24 February 2014

| Subject | 'As-Constructed' Rock Revetment | Job no. | [REDACTED] |

Background

COOK SHIRE COUNCIL
WEBBER ESPLANADE - COOKTOWN
REVTMENT WALL - AS BUILT
DESIGN CHECK - SECTIONS SH2

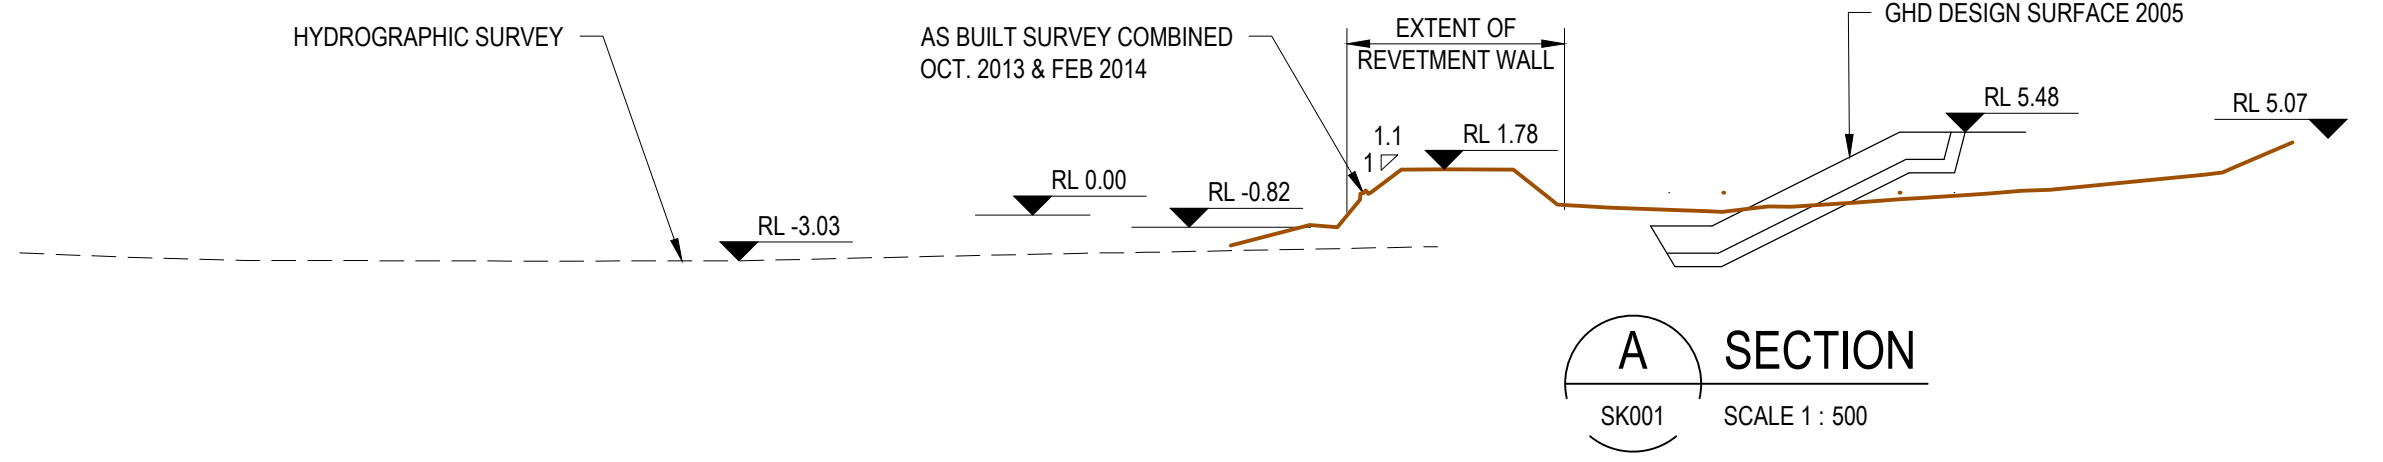
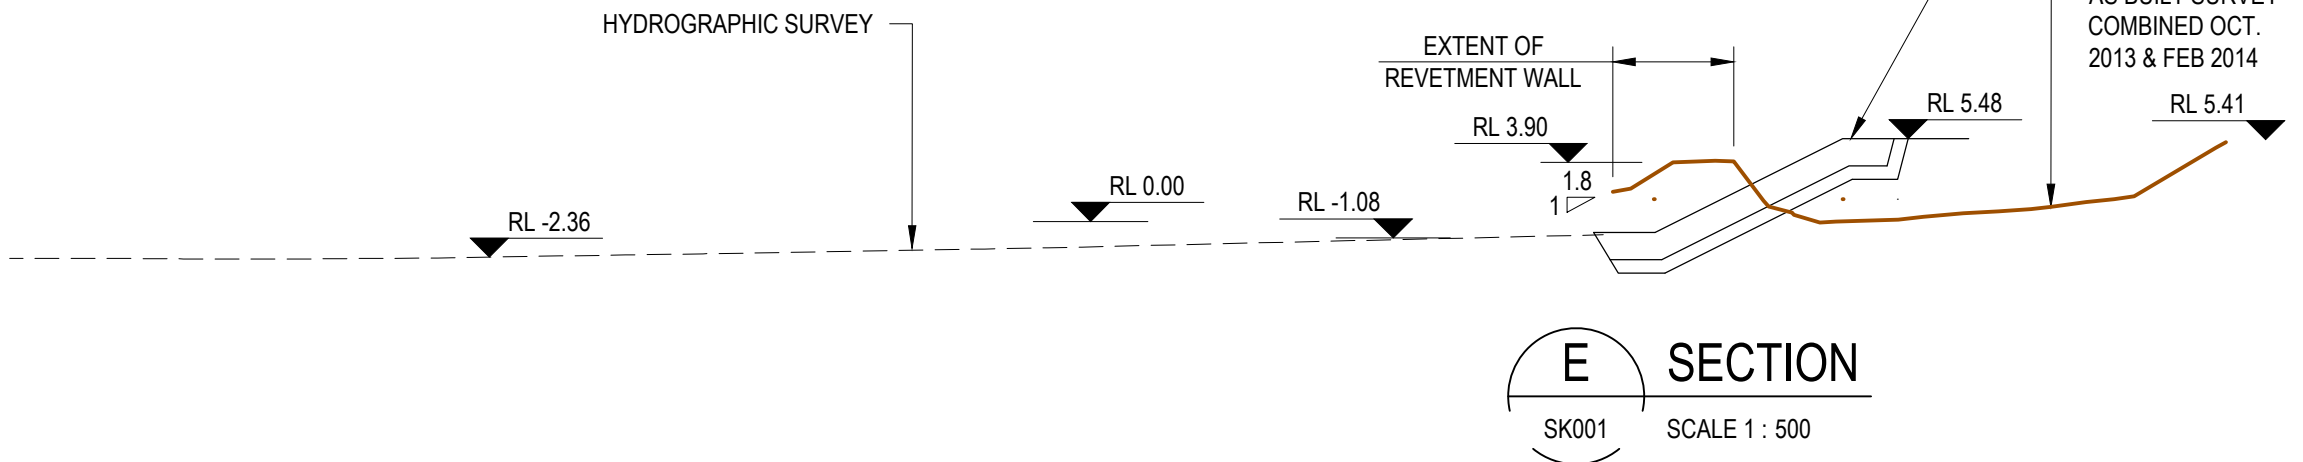
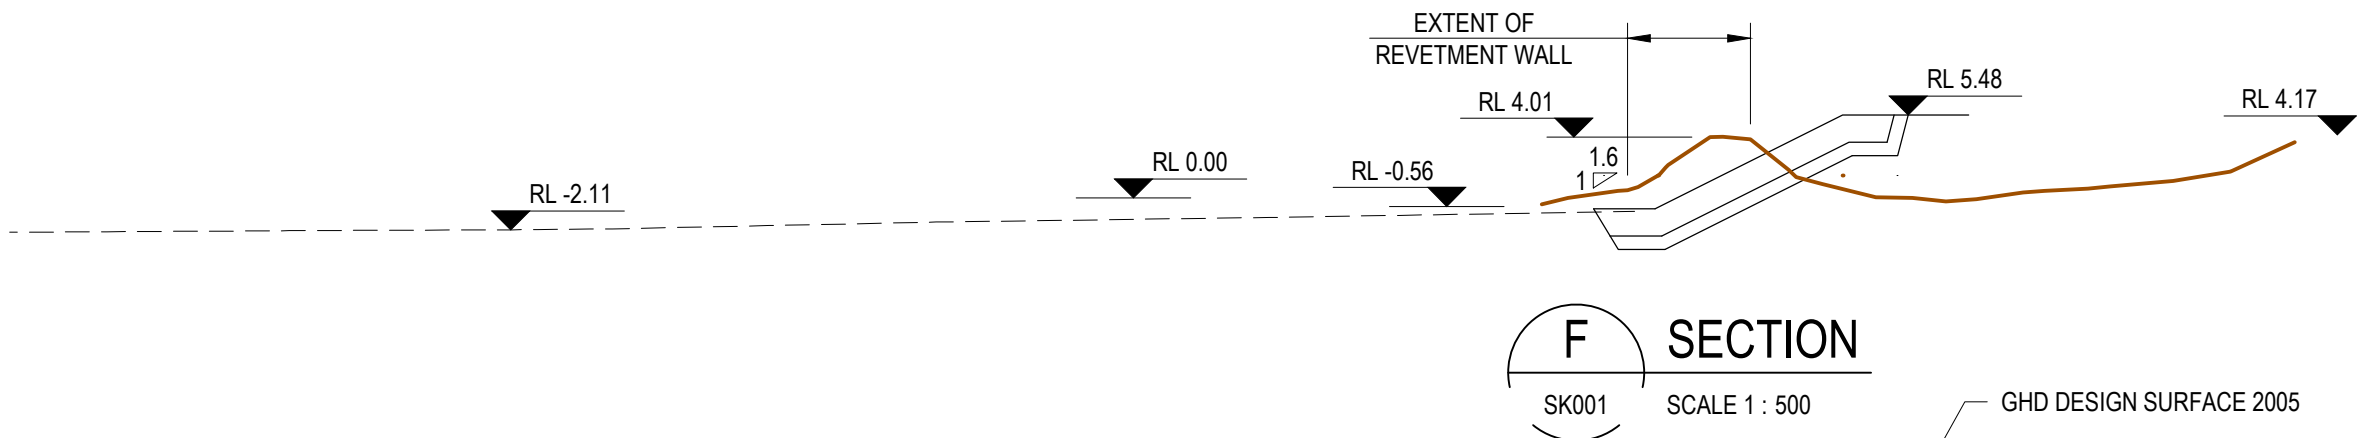
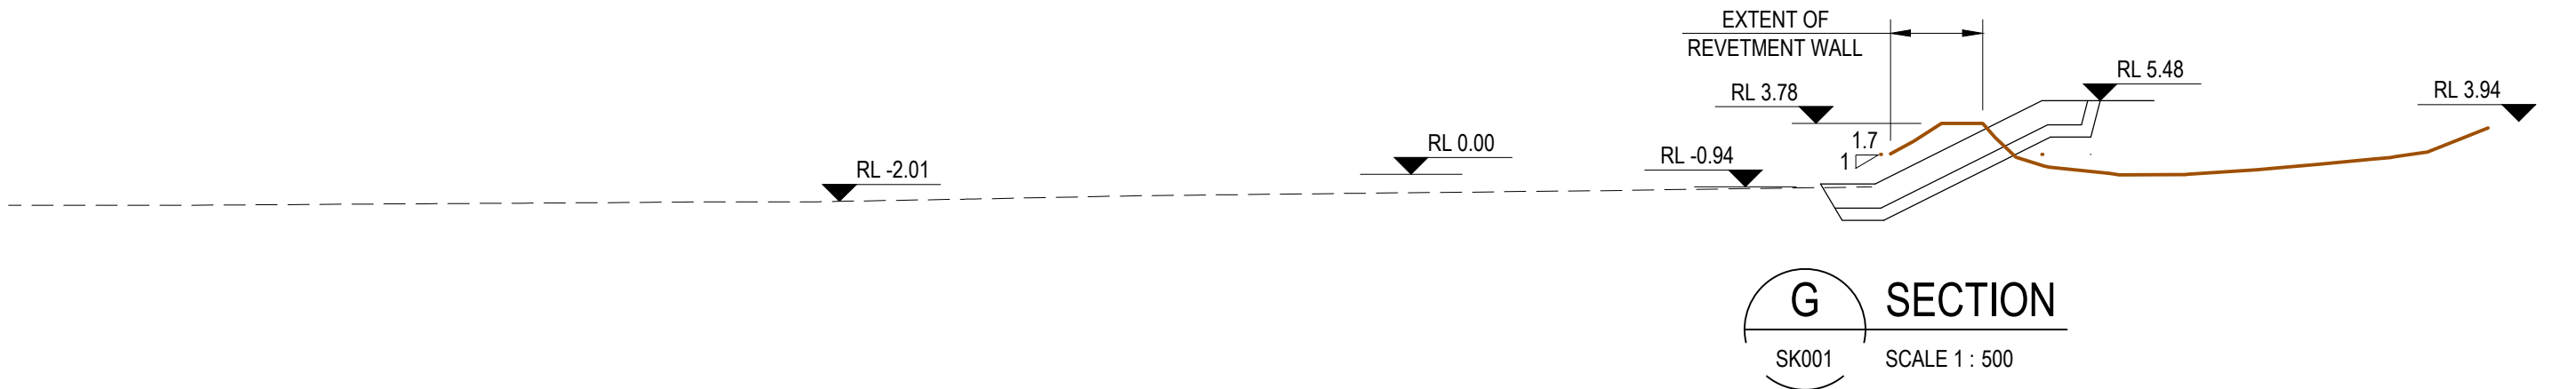
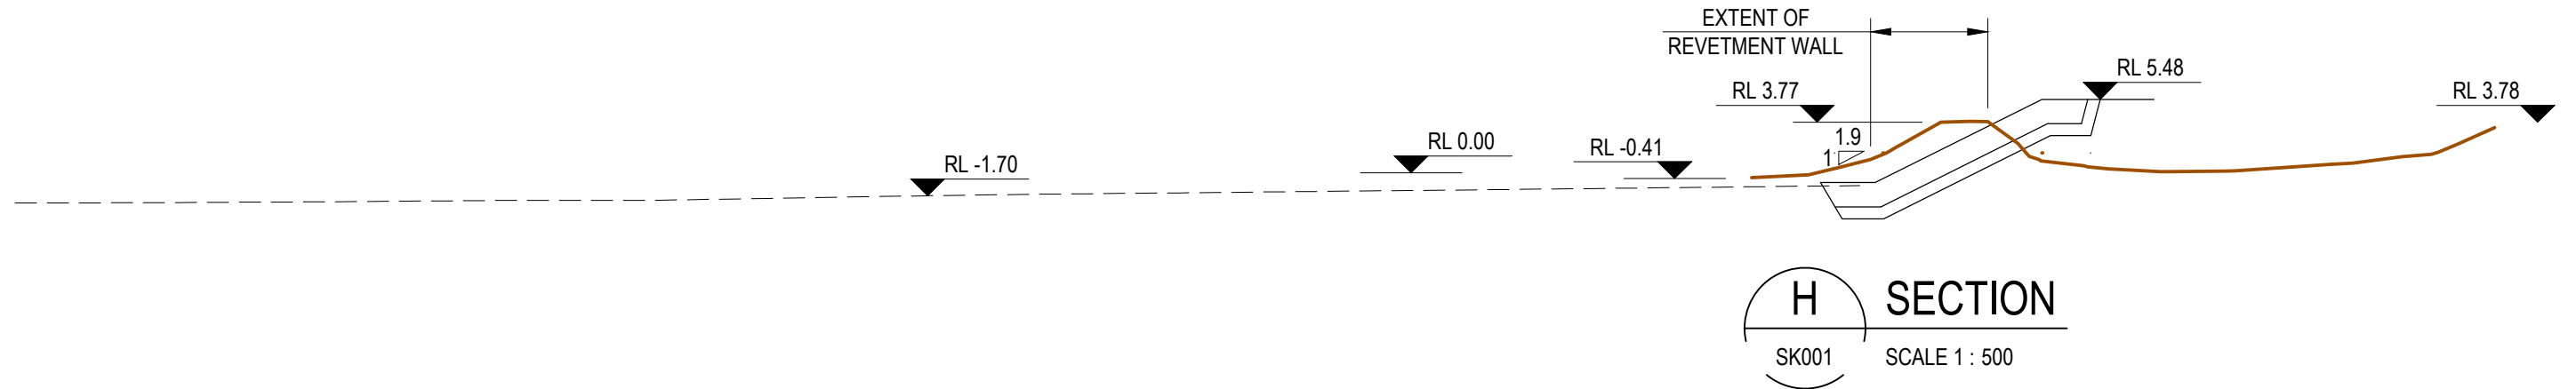
The sections taken from the 'as-constructed' survey, as shown in SK-002 to SK-004 within appendix C, shows that the rock armour slope varies from 1 in 1.1 at the western end trending up to 1 in 2 at the eastern end. If the survey is a true reflection of the 'as-constructed' rock armour slope, it is recommended that additional rock is placed on the armour face in order to obtain the 1 in 2 design slope.

The slope stability analysis was based on cross-sections produced from topographic surveys dated Oct 2013 and Feb 2014 provided to GHD. Cross-section E (Sketch SK-003) was selected for slope stability analysis as it represents the highest part of the revetment wall and has a maximum crest-to-toe height of approximately 5 m.

- Photos taken during construction and QA site records, if available, should be provided in order to confirm the assumptions made during the assessment.
- It is recommended that the seaward face of the revetment be topped up with rock armour to achieve a 1 in 2 slope uniformly along the full length of the revetment.
- Raising the crest finish level with rock armour to +4.98 m LAT is recommended in order to ensure overtopping volumes are within the guidance values provided by CIRIA.
- In the process of raising the crest, the existing small graded rock as shown in photo 4 and 5 should be removed and replaced with rock armour.
- Install the 1200R Elcomax geotextile as per the recommendations provided above.
